| <b>PCN Number</b> | PCN-20210615                             |
| <b>Title</b>      | TE0820-04 eMMC Change and Product Update |
| <b>Subject</b>    | BOM change                               |

Locate eMMC (U6) on top side of PCB:

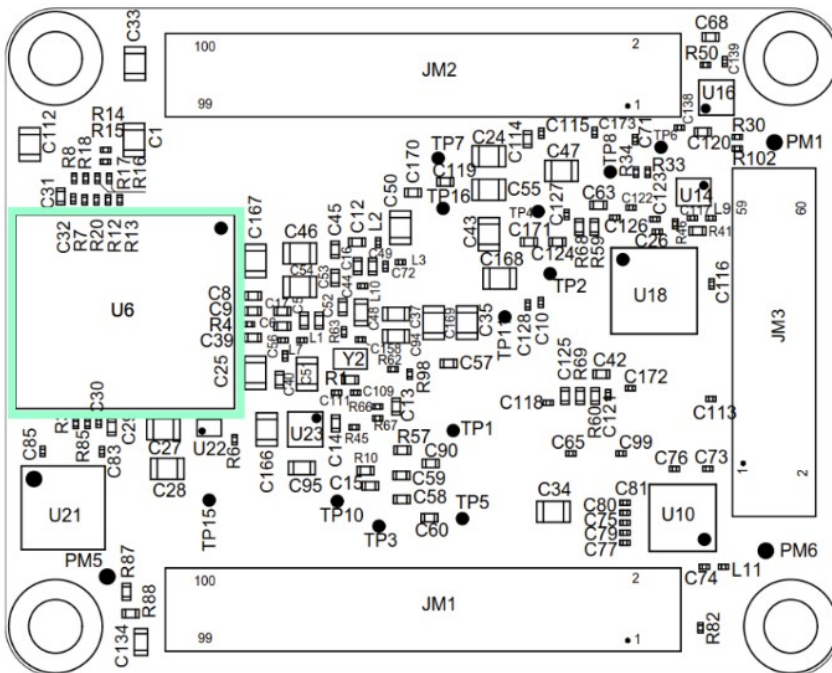
### 2.1 #1 Change eMMC (U6) from IS21ES08G-JCLI / IS21ES64G-JCLI to SDINBDG4-8G-XI2 / SDINBDG4-64G-XI2

**Reason:** Distributor informed about unforeseeable immediate EOL of parts. No official documents from manufacturer are available. No LTB, already confirmed orders were canceled by distributor/manufacturer.

**Impact:** None. Replacement has same capacity as used on corresponding affected variant. Reference designs for vivado versions 2019.2 and 2020.2 were tested and work properly without any changes.

| old   | new  |
|---|--|
| <p><b>IS21ES08G-JCLI</b><br/>or<br/><b>IS21ES64G-JCLI</b></p>                       | <p><b>SDINBDG4-8G-XI2</b><br/>or<br/><b>SDINBDG4-64G-XI2</b></p>                     |
